# **EEE update figure changes**

**Saied Benyamin, Aquantia**

**IEEE 802.3ch Plenary**

Figure 149-2—Functional block diagram

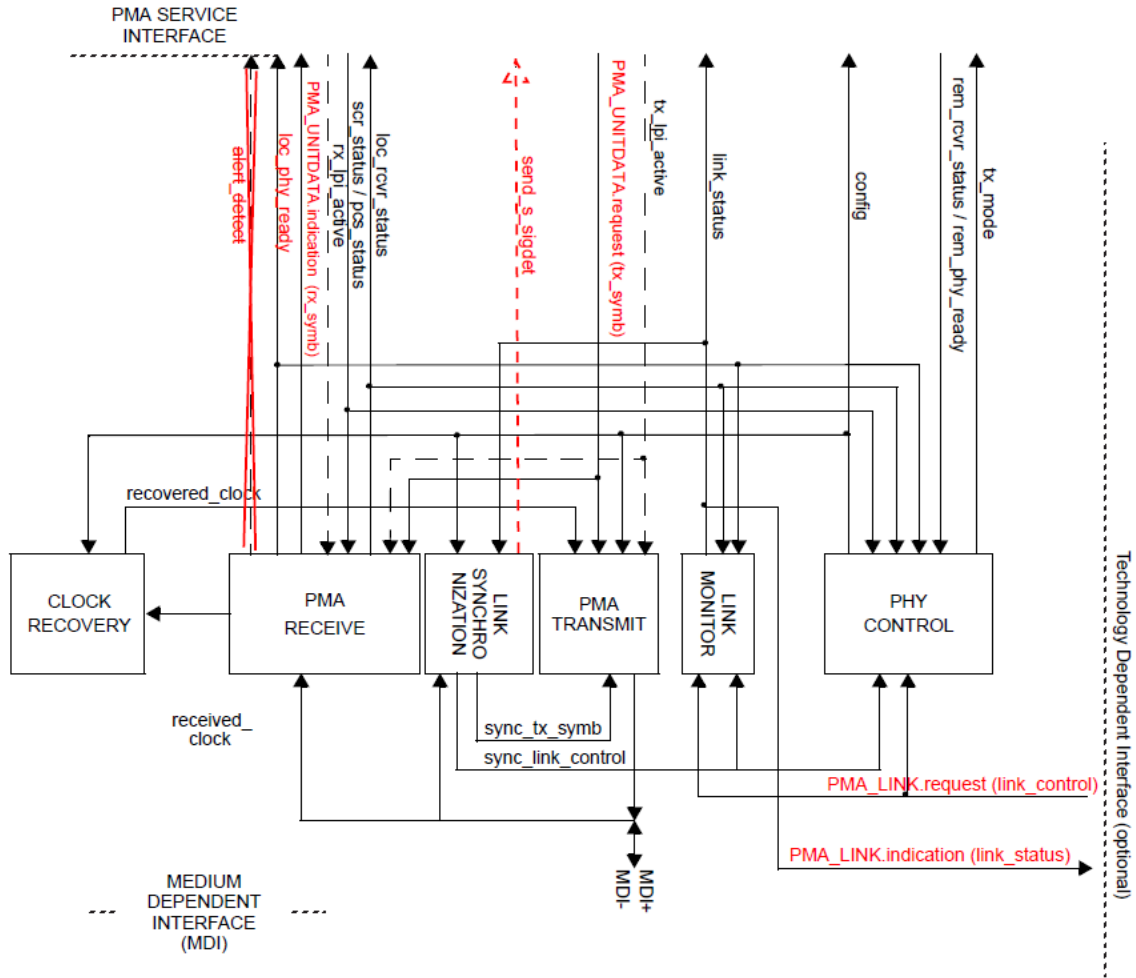
NOTE 2—Signals and functions shown with dashed lines are optional.
